**SECTION: 417**

**Service Action: Right-Hand Rear Lamp LED Failure**

XF (X250)

VIN: R00001 - R61290  
Model Year: 2009 - 2010

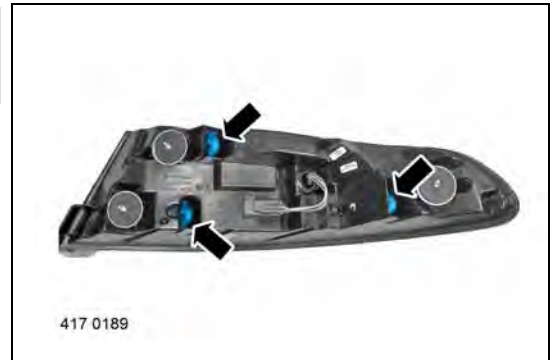
3. Replace the vent tubes:
  - Release and remove the three (3) vent tubes from the lamp assembly.
  - Install three (3) new vent tubes to the lamp assembly.

△ **NOTE: Lamps not being replaced must have the vent tubes replaced. New vent tubes are of a different material specification.**
